**RE: Standard Dredge and Fill Wetlands Permit Application (RSA 482-A)
NHDES File Number: 2022-03478
Subject Property: Barrett Hill Rd, Wilton, Tax Map #A, Lot #44-1**

Per your request for more information dated February 21, 2023 please see clarification below and attached.

On behalf of the Town of Wilton Planning Board, Aries Engineering, LLC (Aries) prepared this letter report to describe our engineering review of available subdivision plans and the drainage report for a 7-Lot Subdivision, proposed by San-Ken Homes, Inc. (Applicant) of New Ipswich, New Hampshire, for an approximate 45-acre +/- parcel identified as Tax Lot A-44-1 (site property) and located on Barrett Hill Road in Wilton, New Hampshire. A site locus plan is depicted on Figure 1.

WETLAND PLAN

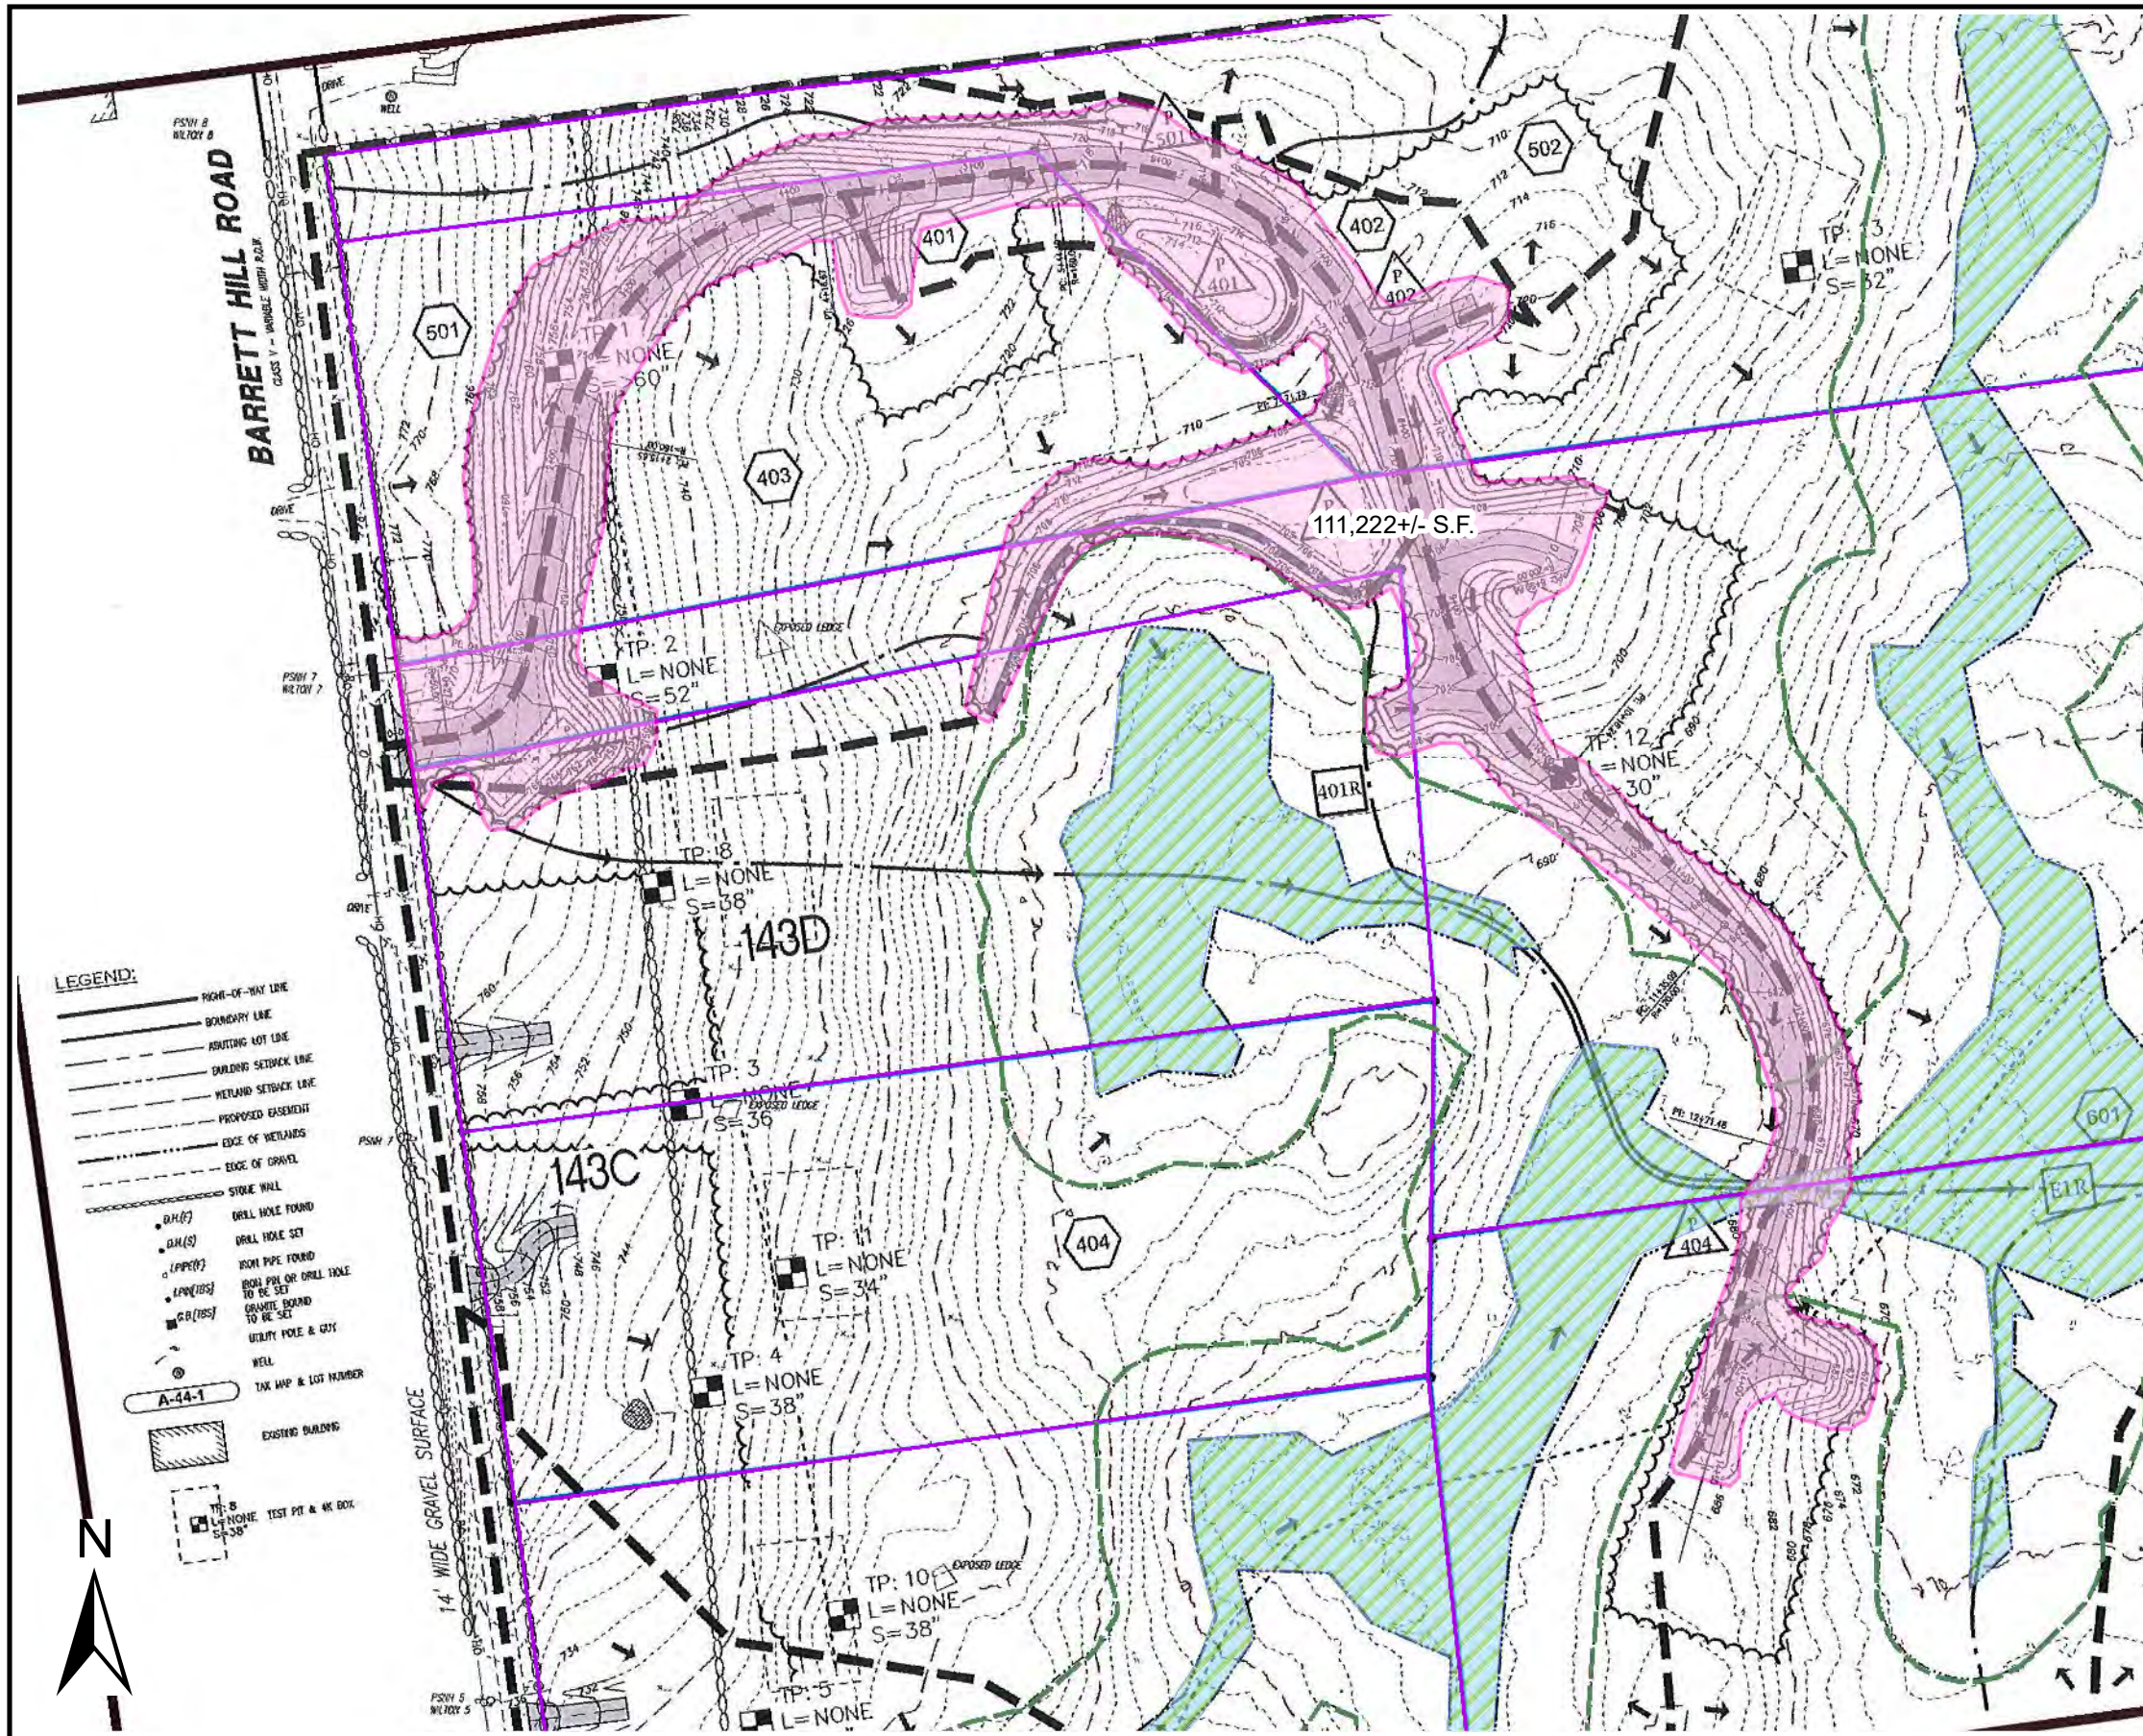
During the site walk, Aries observed possible unmapped wetland soils in the following areas and as shown on Figure 2:

1. Area 1 consists of a low-lying area located along the northern site boundary.
2. Area 2 is an area of tree cutting near the woods road that is located in the west-central portion of the property. Aries observe wetlands flagging around the majority of the delineated wetland areas that appeared to be mapped appropriately. However, the northern wetland boundary flagging had been removed in an area of tree cutting. Aries was unable to confirm the boundary of these wetlands, which appeared to differ in the field from the boundary depicted on the site plans.

the eastern portion of proposed Lot 4. An arrow shown on the site plans in this area depicts a downslope flow of surface water from the isolated wetland area toward this area. This area requires additional wetland delineation.

Aries also inspected the wetland area located along the northern property boundary where a prior wetland survey had been conducted by Fieldstone for the northerly abutting property owner. See attached Figure 2. Aries observed in this area surface water flowing south onto the site property in the area of the site property's flagged wetlands, which were consistent with the mapped wetlands on the site plans. Aries also observed surface water flow to the east along the northern side of the stone wall boundary on the abutting property, which appeared to be consistent with the mapped off-site wetland areas. The observed wetland areas on both the site and northerly abutting property appeared to be consistent with the wetland mapping.

Area 1 as shown on Figure 2 is a topographic low point in the overall surrounding topography of approximately 30'x30' located against the stone wall on the northern property line. Rainwater infiltrates into the well-drained soil within and around Area 1 and based on numerous site visits throughout every season we have observed that there is no sustained surface water for more than 2 weeks during the growing season or dominance of hydric soils or hydric vegetation within Area 1. In accordance with US Army Corp of Engineers 1987 Manual for Wetland Delineation, the subject area must meet at least the 3 criteria to be classified as Jurisdictional Wetlands, 1) a dominance of Hydric Soil, 2) a dominance of Hydrophytic Vegetation and 3) sustained Hydrology present long enough to create the other 2.

Area 2 as shown on Figure 2 was reviewed multiple times during site walks with Planning Board, Zoning Board as well as NHDES Wetlands Bureau. The area has been logged and is an area of one of the timber harvest roads that was travelled many times by heavy equipment. Foresters and loggers make every effort to avoid any wetlands areas and as such typically travel around wetlands areas; it is not uncommon for there to be areas with higher water tables within the soil the closer one gets to the wetland boundaries. The conditions present in Area 2 is similar to Area 1 in the fact that it does not contain the 3 parameters required to be classified as a Jurisdictional Wetland. Travel by timber harvest equipment may have disturbed soil, stones and vegetation along the skid trail that appears to have temporarily altered soil surface conditions that may include areas of temporary ponding and seasonally high water table. Wetland delineation and survey location was conducted prior to timber harvest activities in natural and undisturbed conditions and Area 2 does not exhibit the criteria necessary to be classified as a Jurisdictional Wetland.

Area 3 as shown on Figure 2 is adjacent to Area 2 and was also reviewed multiple times during site walks with Planning Board, Zoning Board as well as NHDES Wetlands Bureau. The area in question is located in the middle of one of the main skid trails utilized during the timber harvest. The area is not Jurisdictional Wetland but is a shallow swale within the overall topography and may concentrate storm-water run-off during spring melt and storm events; as such the logging company utilized best management practices (BMP) for minimizing erosion and environmental impact by laying down small trees and branches within the swale (sometimes referred to as a corduroy crossing) to minimize soil impact by harvesting equipment and allow for storm-water to pass through and under the branches to minimize potential soil erosion source. The logging company again followed BMPs by removing the woody branches that were placed in the area after the timber harvest was completed to restore natural conditions to the best extent practicable. The land surface in this area has not been re-graded; the residual wooden debris is over 2-3 ft thick in places and branches on either side of the swale center have not been removed as they are typically allowed to degrade in place to allow for the replacement of organic material into the soil and environment which is the recommended and environmentally responsible practice for timber harvest activities. These same conditions exist at the proposed wetland crossing location. It is possible that snow cover at the time of Aries inspection may have obscured the natural grade and site conditions, however, all the wetland areas on the property, including Area 3 have had extensive multiple reviews pre and post timber harvest activities and through every season by multiple Certified Wetland Scientists. In our professional opinion, the wetland delineation conducted is accurate and appropriate and does not require additional wetland delineation.

PROPOSED DISTURBANCE AREA PLAN

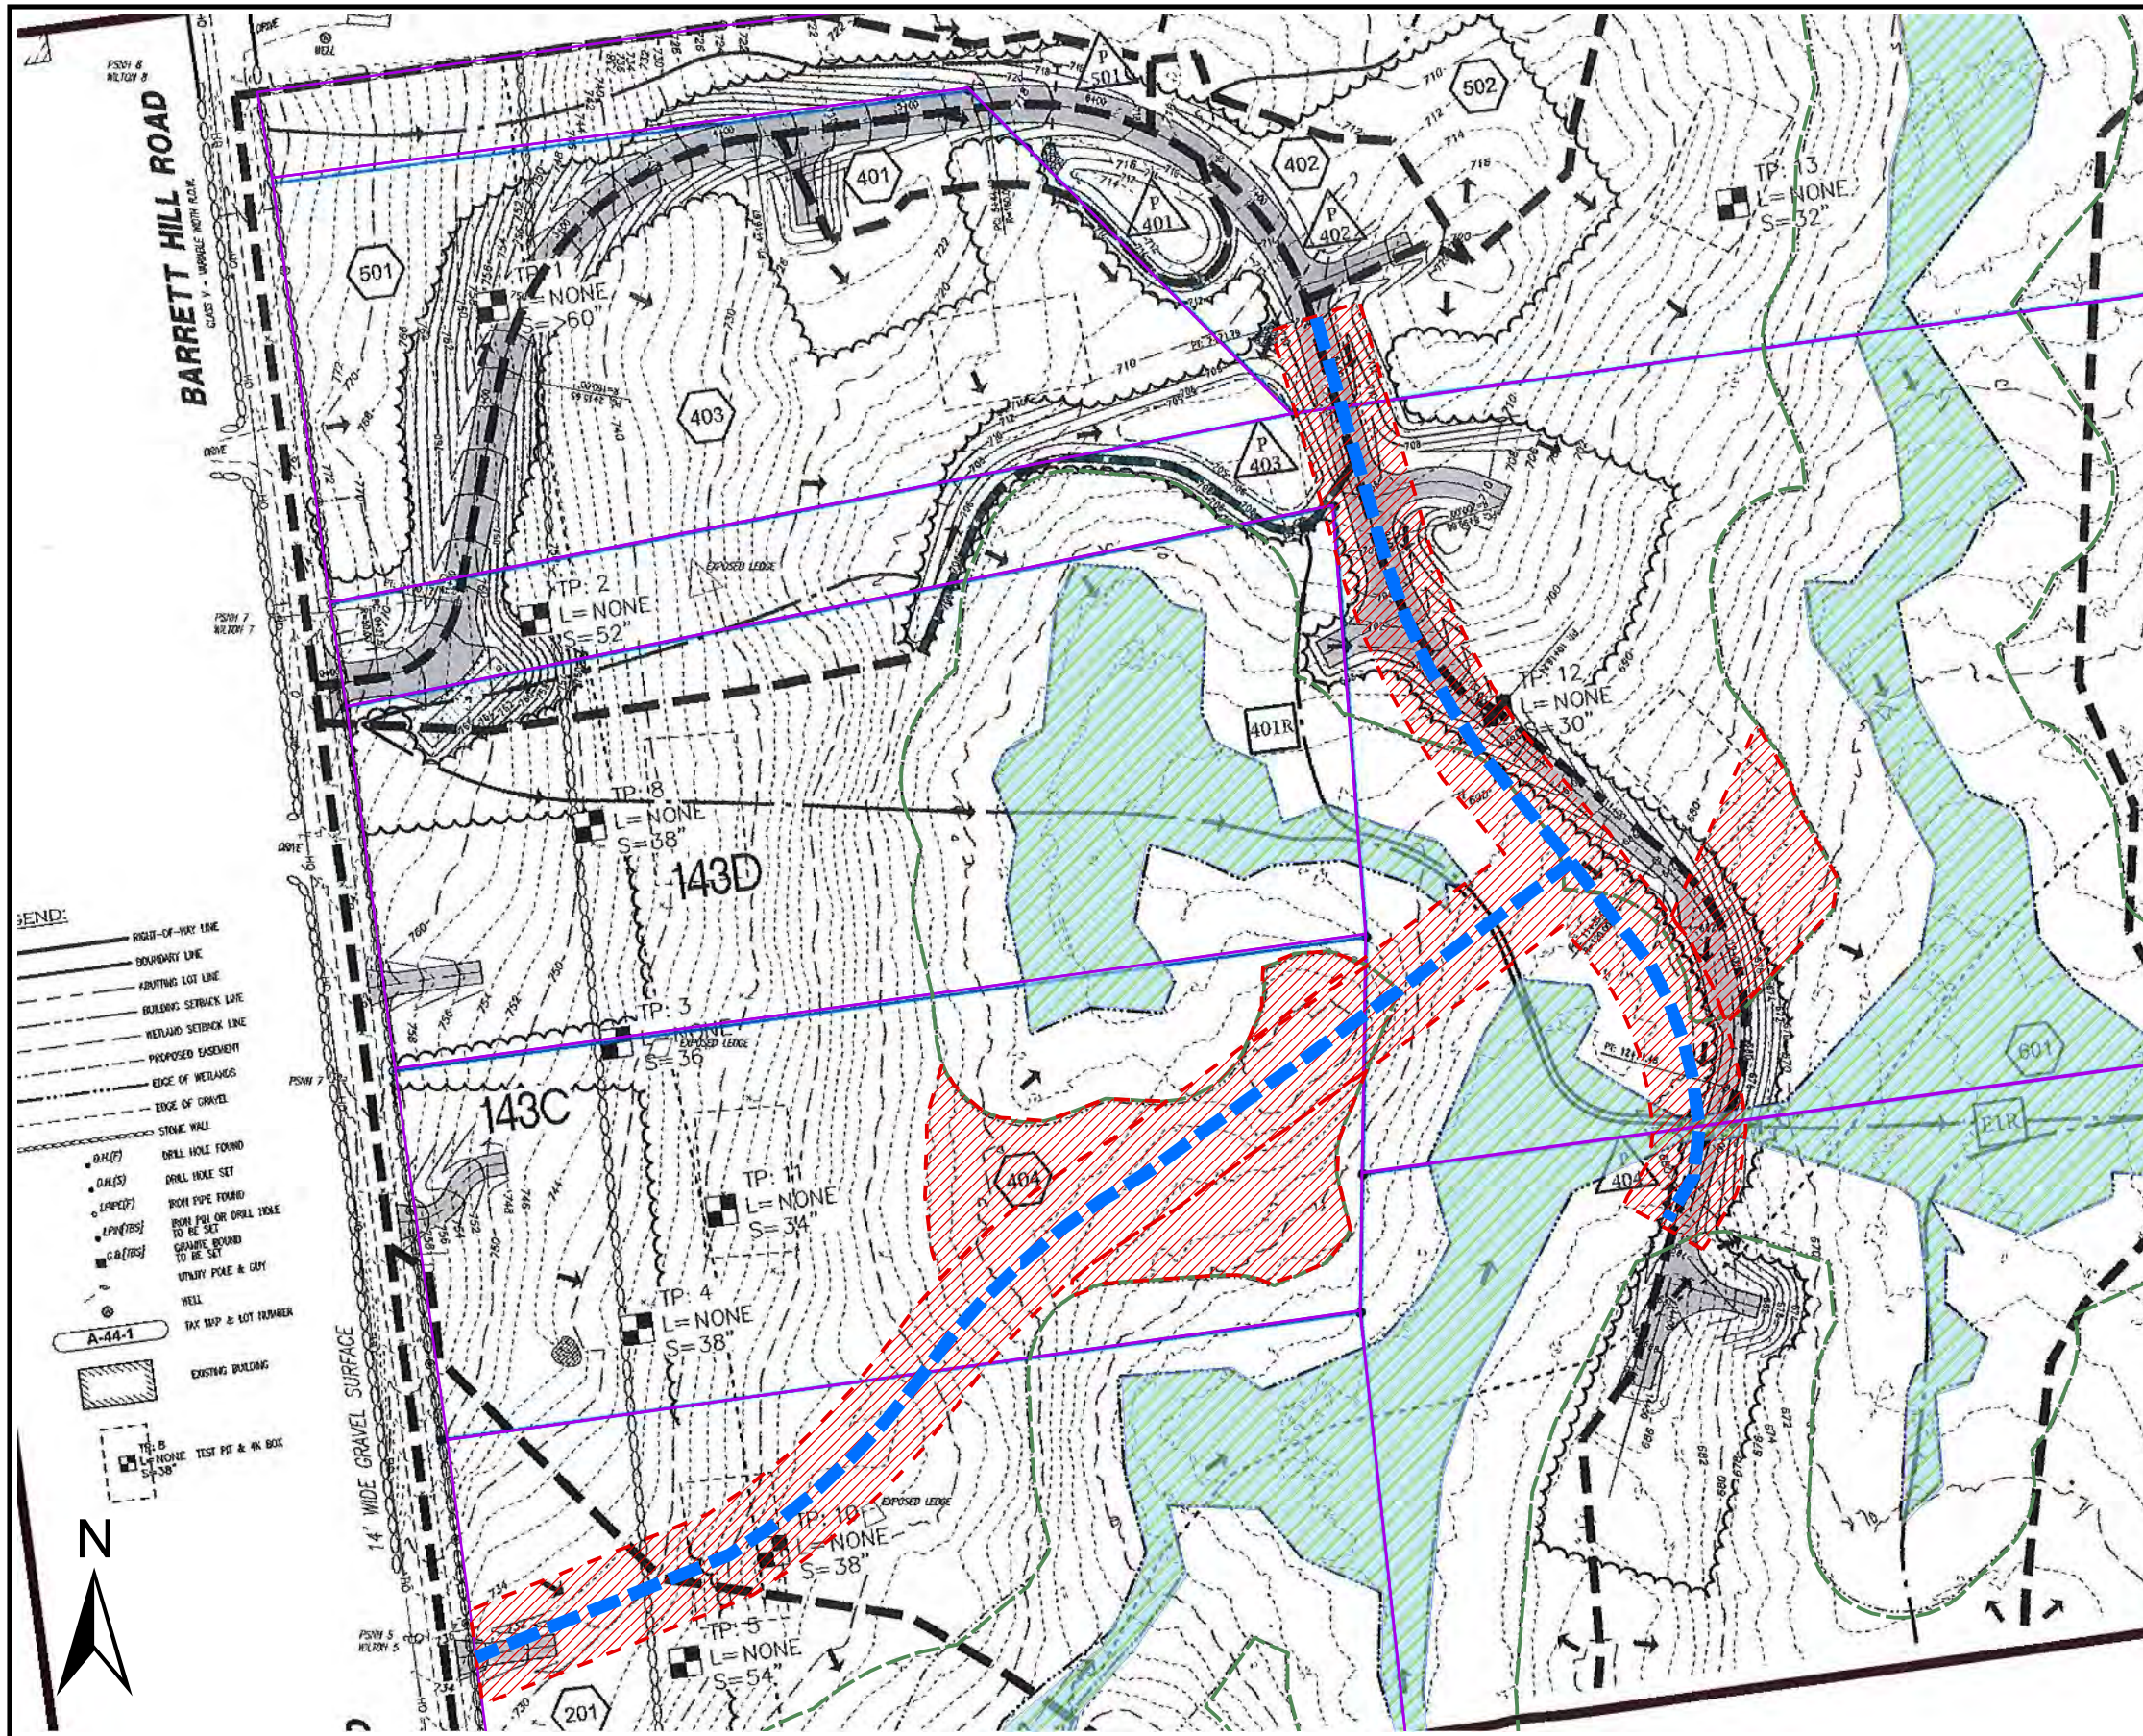
Attached Figure 3 depicts the proposed common driveway, which travels steeply downslope from Barrett Hill Road at grades up to 10%. The driveway is located in proximity to abutting residences and is anticipated to provide greater intensity of use than is normally associated with single-family residential development. Shielding and buffers that limit disturbance to off-site properties are recommended to be deployed between existing and proposed land uses. At a minimum, stockade fencing should be installed along the northern property boundary to limit light glare and noise from the proposed common driveway.

8. Aries used GIS software to calculate the proposed disturbance area associated with common driveway, which was estimated to be approximately 111,220 +/- .s.f. This value exceeds the threshold for the NHDES AoT permitting requirement. Attached Figure 4 depicts the assessed disturbance area.
